**RE: Response to USEPA Comments (dated 02/26/15) on Focus FS Report – Revision 1 and Submittal of Focused Feasibility Study Report – Revision 2**

Waukegan South Plant Manufactured Gas Plant (MGP) facility in Waukegan, Illinois  
North Shore Gas Company

**CERCLA Docket No. V-W-'07-C-877**  
**CERCLIS ID – ILD984809228**

Figure 16 – PRELIMINARY Framework for DNAPL Recovery  
Performance Standard  
Former South Plant Site  
North Shore Gas

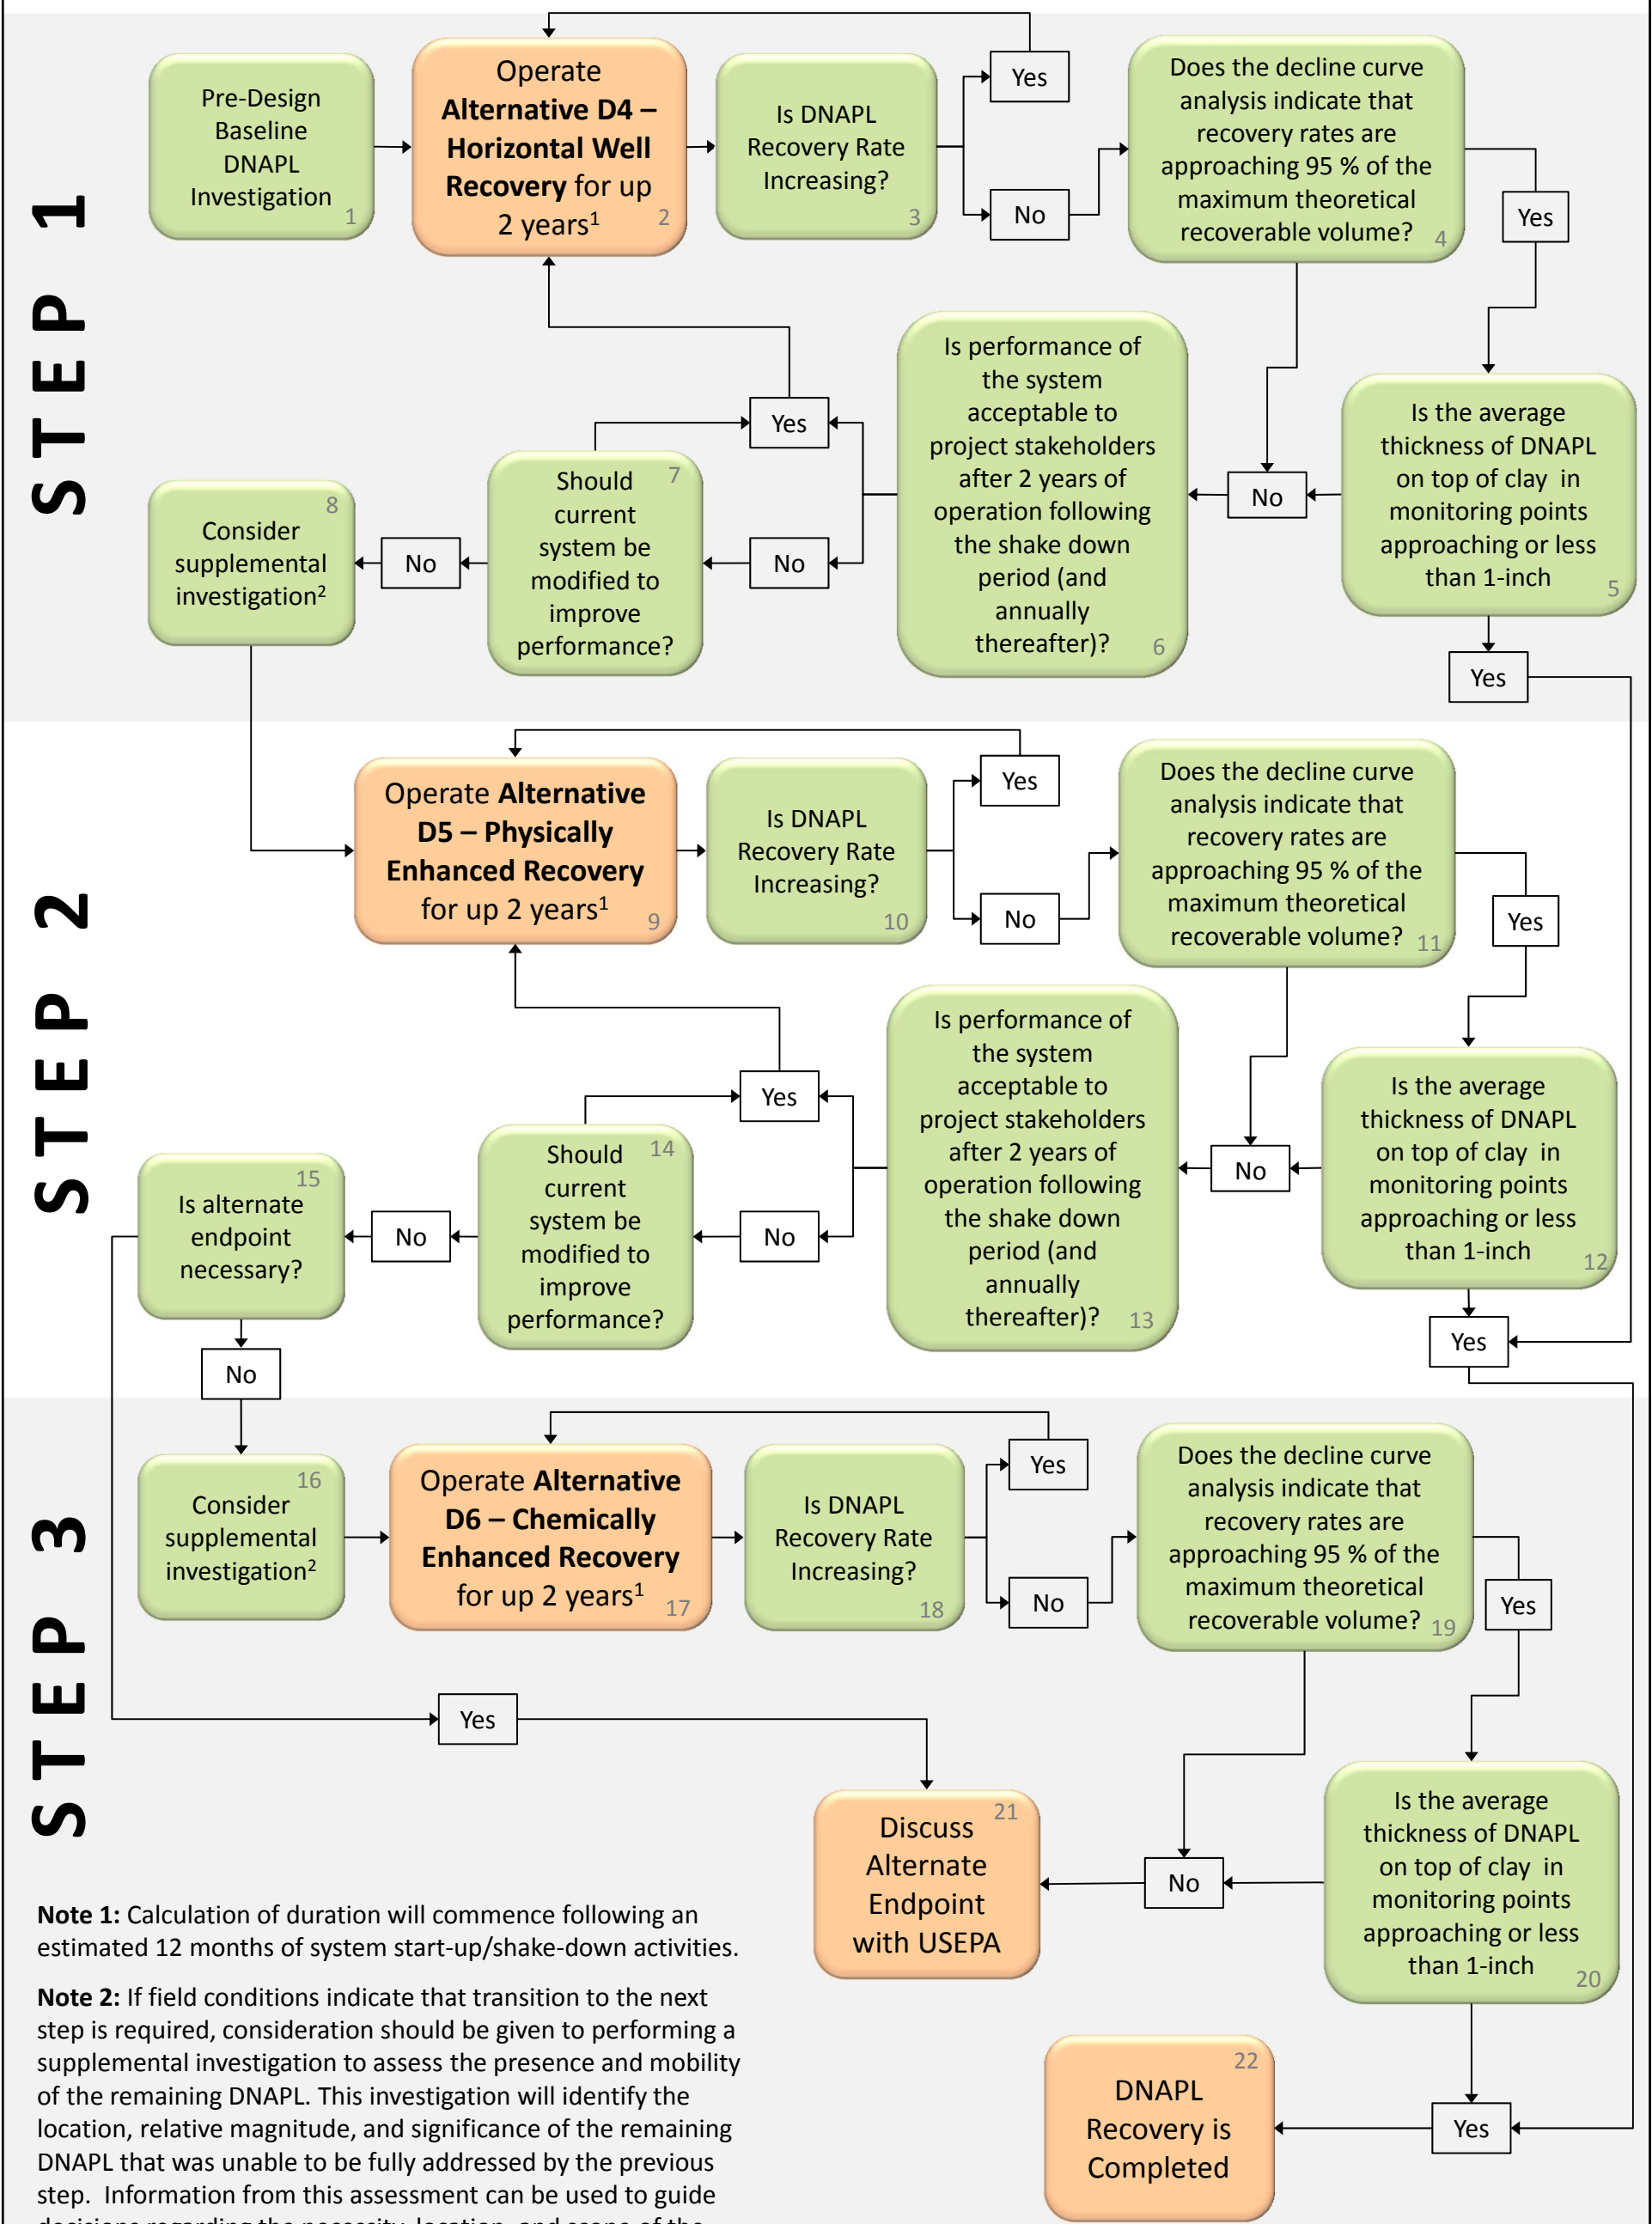
5. ***In Reference to Previous USEPA FFS Specific Comment #1 and IBS's Response:*** *As is specified in the revised FFS Section 4.5.2, it is requested that the DNAPL pre-design investigation take place before implementation of Option D4. Figure 16 should be modified accordingly to show the pre-design DNAPL investigation occurring before implementation of option D4, and language in Sections 6.3 and related Section 6.2 should be clarified to reflect the pre-design investigation. Pre-design investigations should be done as soon as possible to provide an updated baseline of DNAPL presence, mobility, thickness, and volume which will assist in not only locating horizontal wells, but also in providing information that will allow better assessment of DNAPL presence across the site. The details of the pre-design investigation can be provided in the planning phase, however, Integrys should plan to integrate analytical approaches to measure pore fluid saturation, interfacial tension, and mobility thresholds in the subsurface that could provide important information for system design. These approaches, if applied before and after remediation phases, could be very useful in demonstrating how the system was performing (along with operational data observations).*

6. ***Figure 16 Additional Comments:*** *See attached recommended changes to Figure 16.*

*STEP 1. Draft versions of this figure presented on January 8 indicated that field monitoring (i.e., a measureable decrease as illustrated by monitoring) would serve as the decision metric. However, the revised Figure 16 includes a metric which is undefined and appears insufficient for decision making purposes (See proposed modifications to Figure 16).*

*STEPS 1-3. The current decision flow did not appear to allow the process to continue to the next step after 2 years (See proposed modifications to Figure 16).*

**IBS Response:** A pre-design investigation box has been added to Figure 16 in advance of Option D4. As discussed with USEPA, the exact details of this investigation will be tailored to the selected remedial option and will be developed in a remedial design work plan. IBS will consider the value of the referenced analytical approaches during the Proposed Remedial Action Plan and Record of Decision Process. As such, no changes have been made in the Focused FS Report.

**IBS Response:** Figure 16 has been updated based on the discussions during the March 11, 2015 conference call and the modified figure provided by USEPA in an email sent on March 12, 2015.
